Addendum No. 001

Subject: William Rowen School – Classroom Modifications
SDP Contract Nos. B-063C, B-066C of 2017/18

This Addendum, dated May 9, 2018, shall modify and become part of the Contract Documents for the work of this project. Any items not mentioned herein, or affected by, shall be performed strictly in accordance with the original documents.

DRAWING NO.
E112

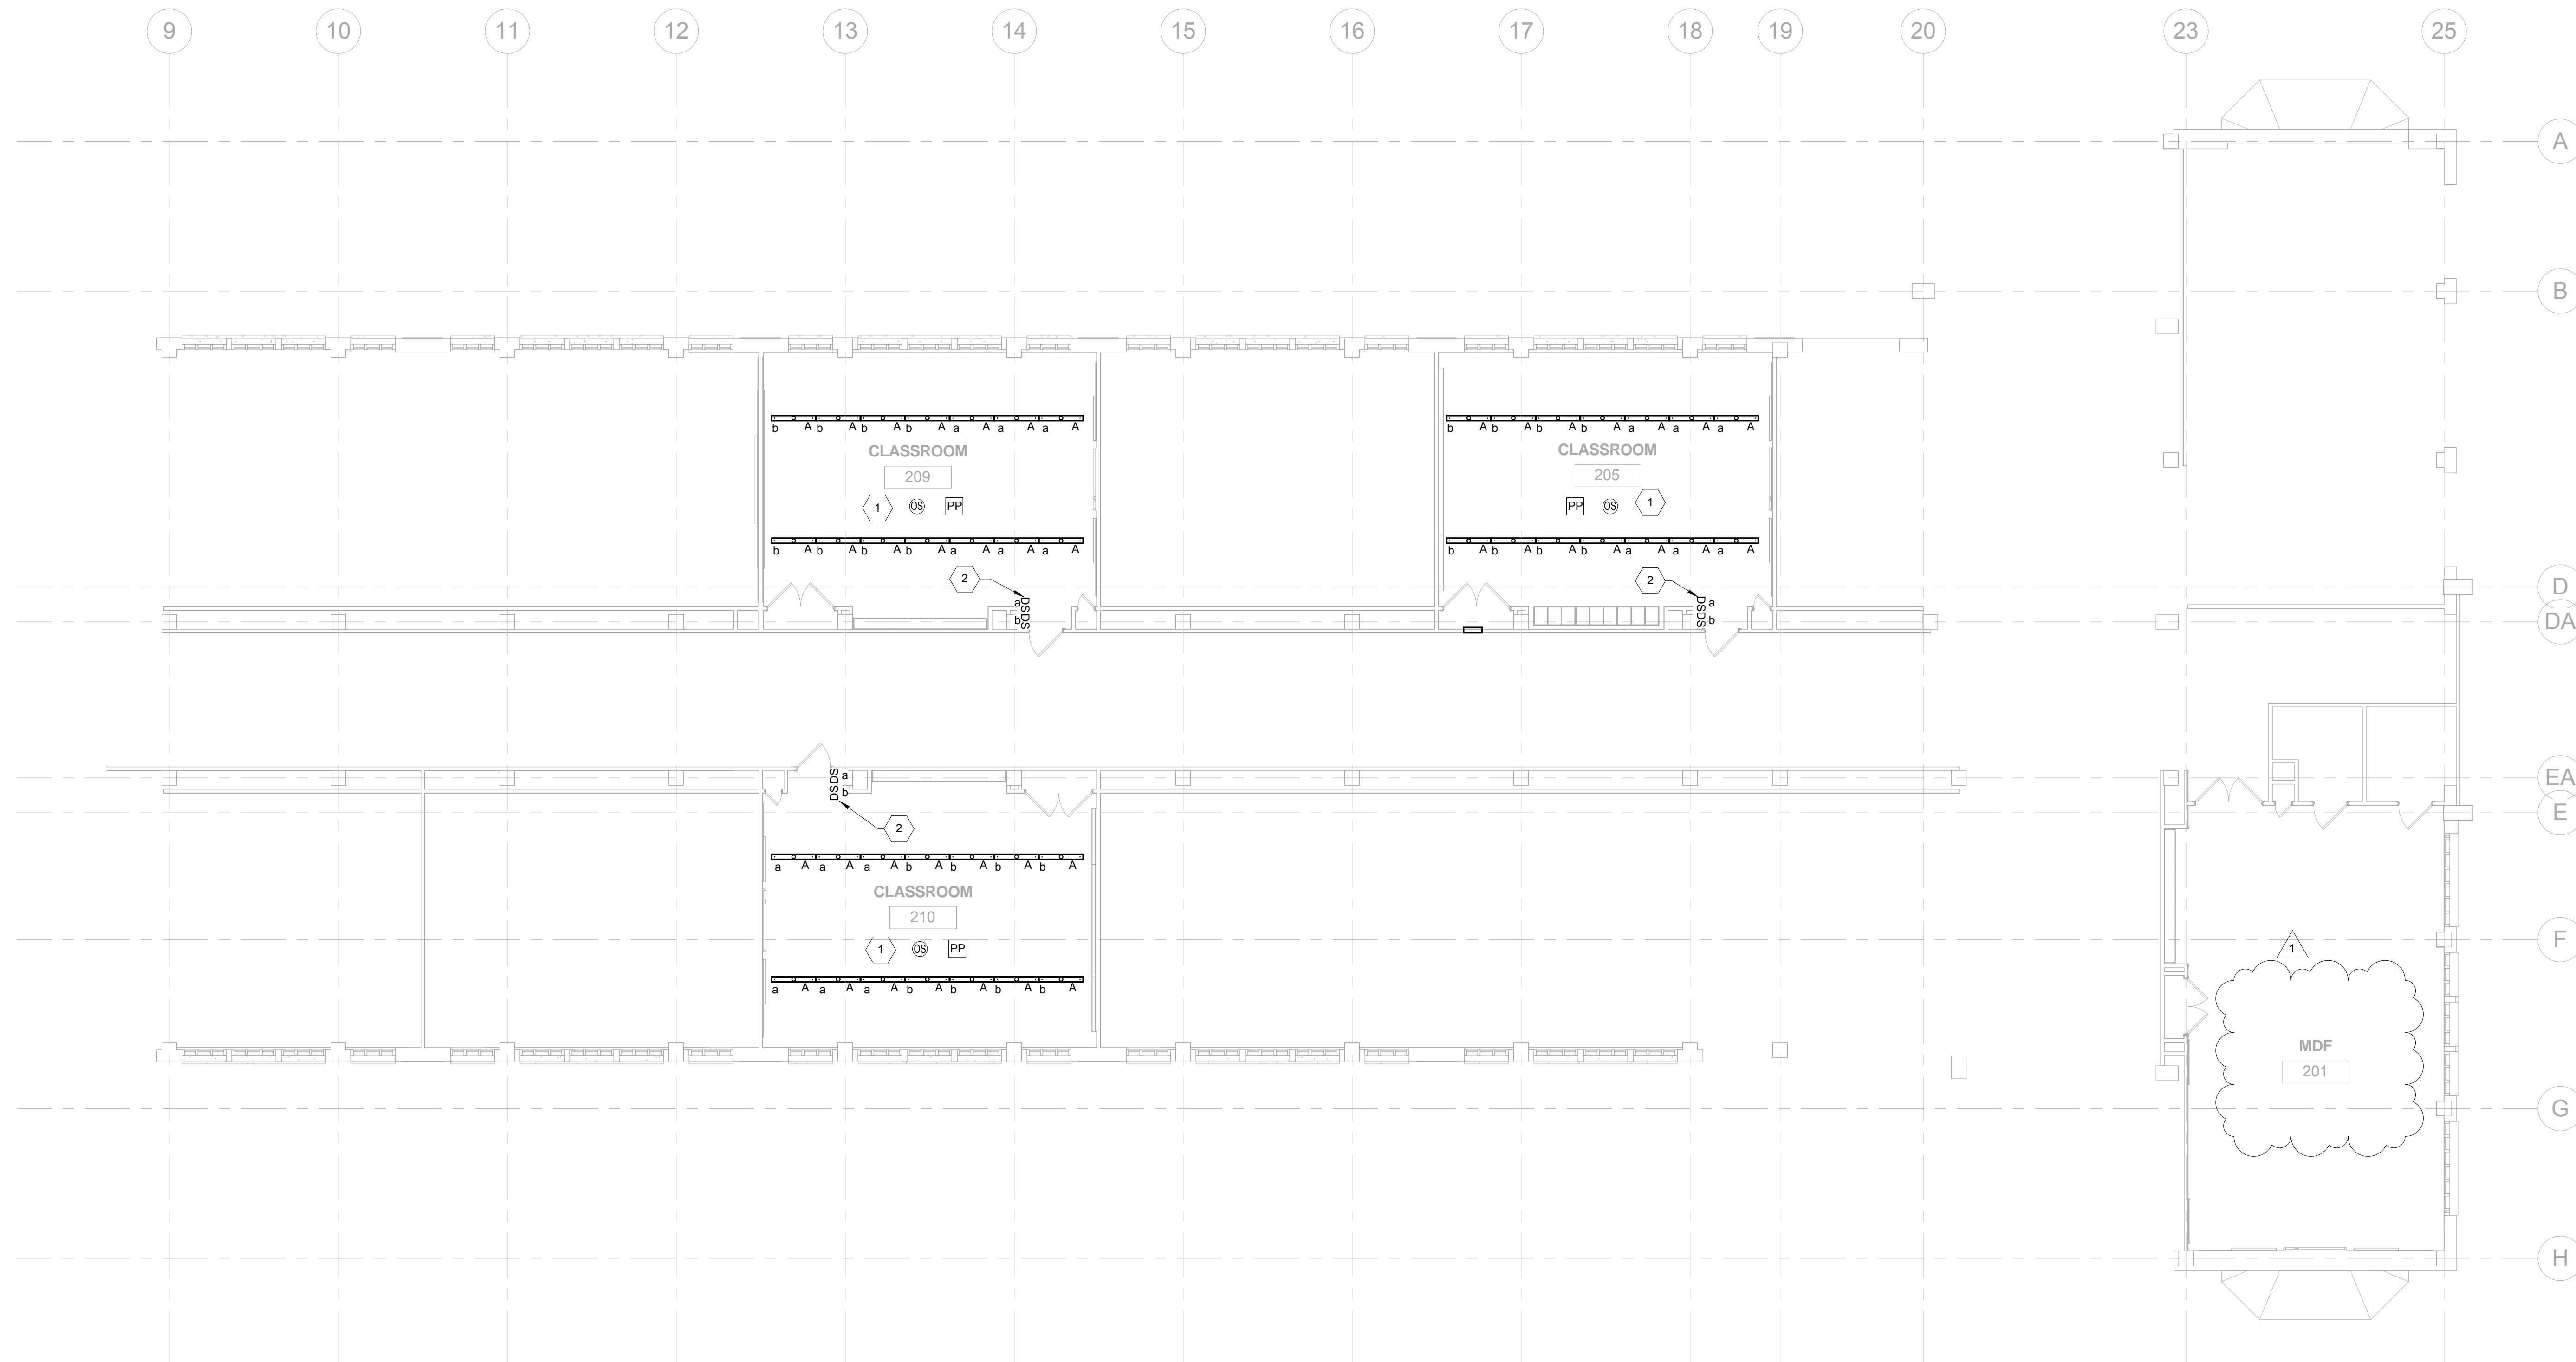
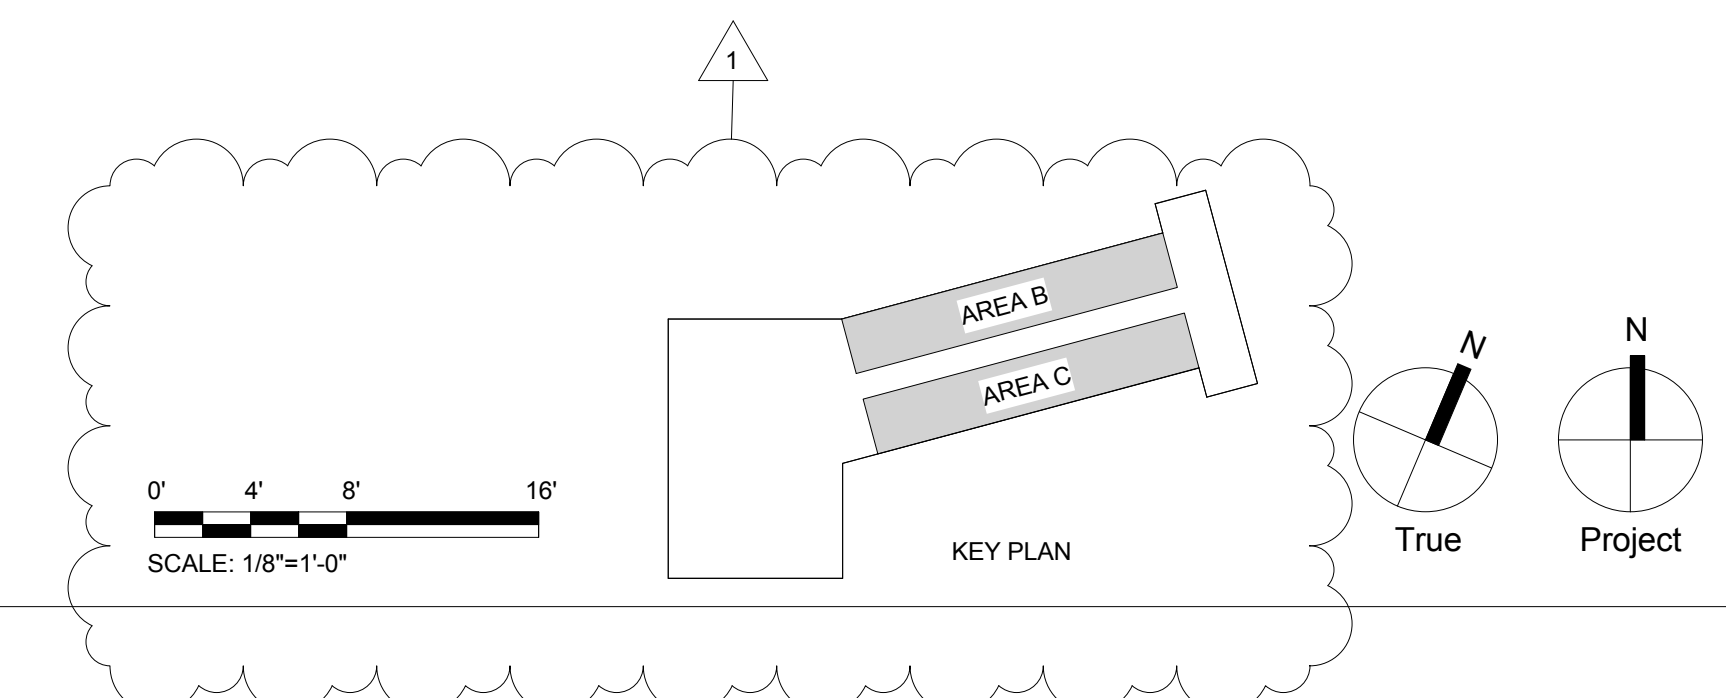
- a. Added MDF room 201.
- b. Add Key plan

DRAWING NO.
E121

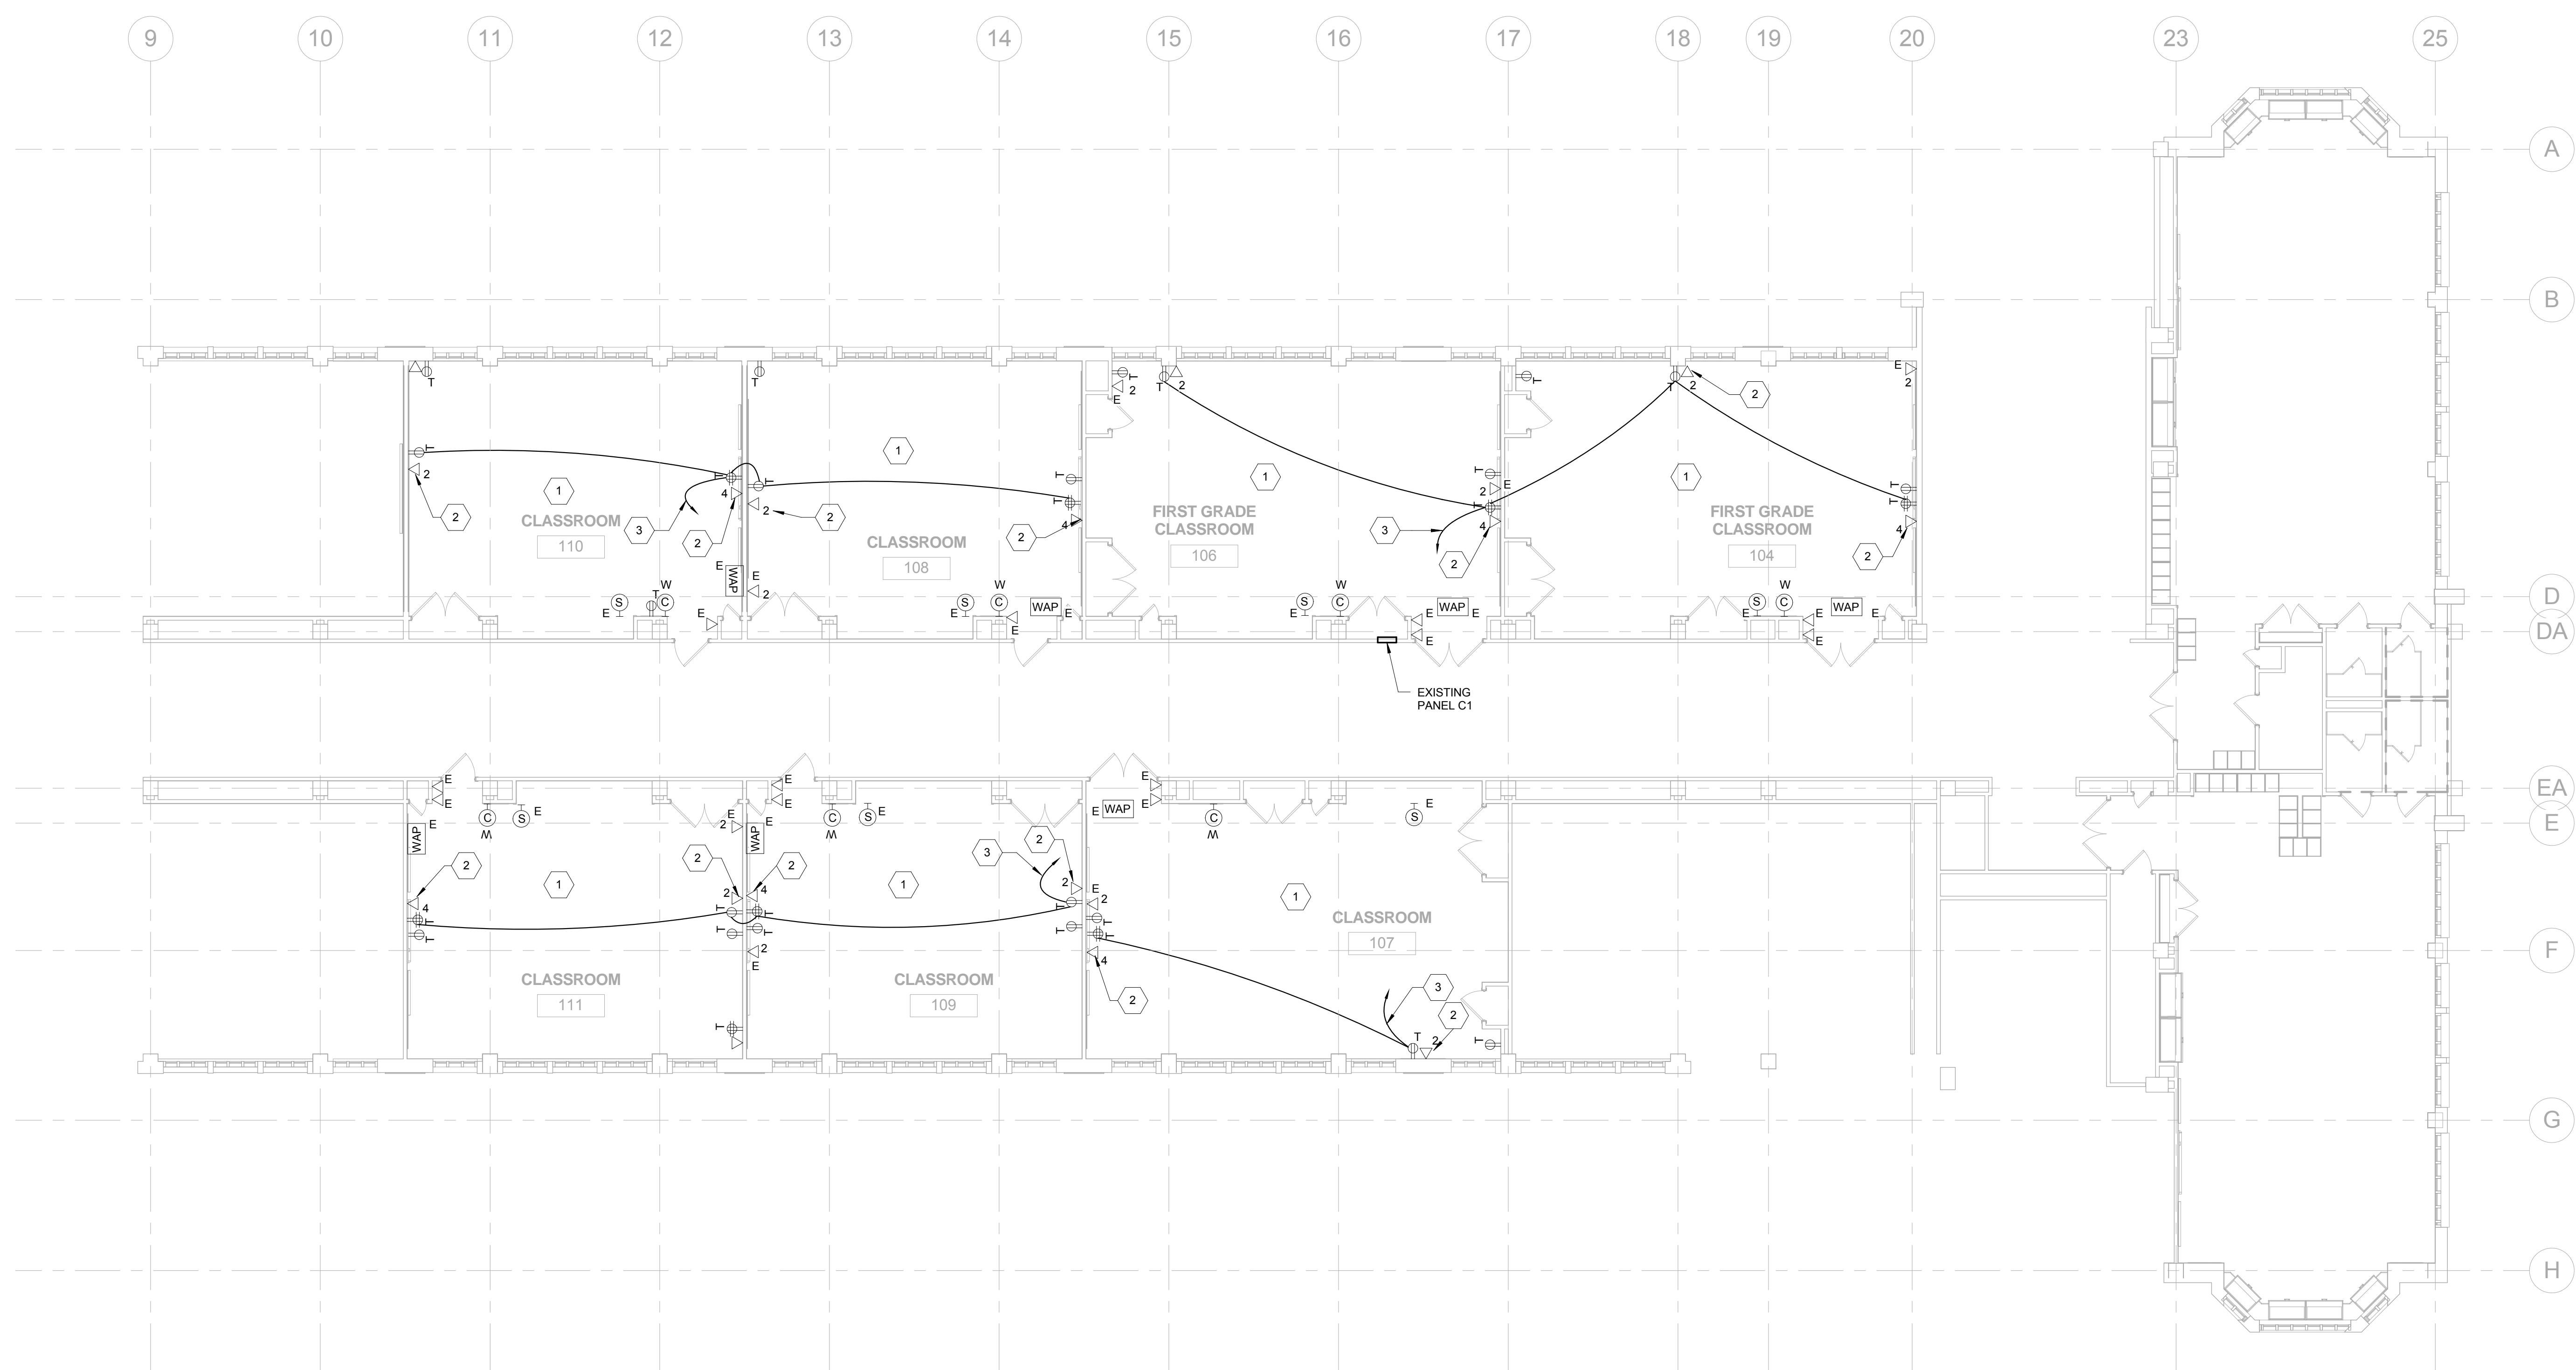
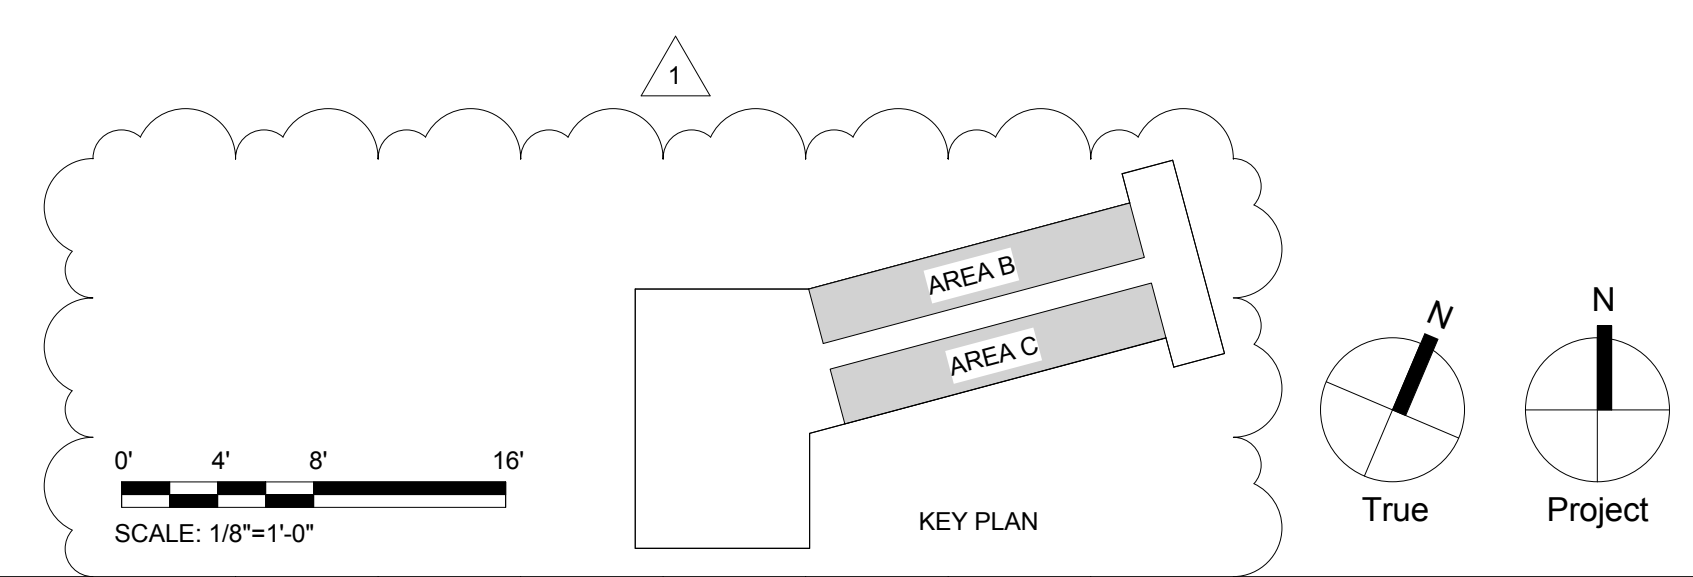
- Revisions:
a. Add Key plan.
